Access Compliance Report

(Curb Ramps)

Intersection ID: 10470	Main Street: MILTON_RD	Cross Street: PERTH_CT	Location: NE
ADA ID: 07307ADAF606	Ramp Type: PerpDiag	Initial Pass/Fail: Fail	Overall Compliance: No
Severity Score: 31.25			
Codes/Mitigation Info/Possible Solution		Field Measurements/Component Compliance

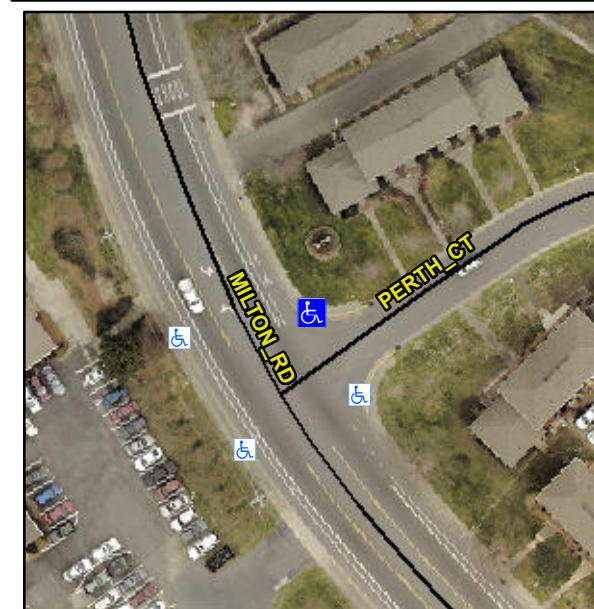
Not Found, R304.5.1, R304.2.2, R304.5.3

Compliance	Description	Data	Compliance	Description	Data
N/A	Ramp Length (in)	59.5	No	Ramp Slope (%)	10.2
No	Ramp Width (in)	35.0	No	Ramp XSlope (%)	2.4
N/A	Flare Type LT	N/A	N/A	Flare Type RT	N/A
N/A	Flare Slope LT (%)	N/A	N/A	Flare Slope RT (%)	N/A
N/A	Flare Traversable LT?	N/A	N/A	Flare Traversable RT?	N/A
N/A	Landing Length (in)	N/A	N/A	DWS Provided?	N/A
N/A	Landing Width (in)	N/A	N/A	DWS Contrast?	N/A
N/A	Landing Slope (%)	N/A	N/A	DWS Length (in)	N/A
N/A	Landing X Slope (%)	N/A	N/A	DWS Full Width?	N/A
N/A	Landing Curb? (Y/N)	N/A	N/A	DWS Offset (in)	N/A
N/A	Shared Landing?	N/A			
N/A	Gutter Ponding?	N/A	N/A	Gutter Slope (%)	N/A
N/A	Gutter Lip Ht (in)	N/A	N/A	Gutter X Slope (%)	N/A
N/A	Painted X Walk1?	No	N/A	Painted X Walk2?	No
	X Walk 1 Direction	To W		X Walk 2 Direction	To SE
N/A	X Walk 1 Width (in)	N/A	N/A	X Walk 2 Width (in)	N/A
	X Walk 1 Slope (%)	5.0		X Walk 2 Slope (%)	0.1
	X Walk 1 X Slope (%)	3.1		X Walk 2 X Slope (%)	1.6

Remove & Replace Curb Ramp With Two New Directional Ramps or Equivalent.
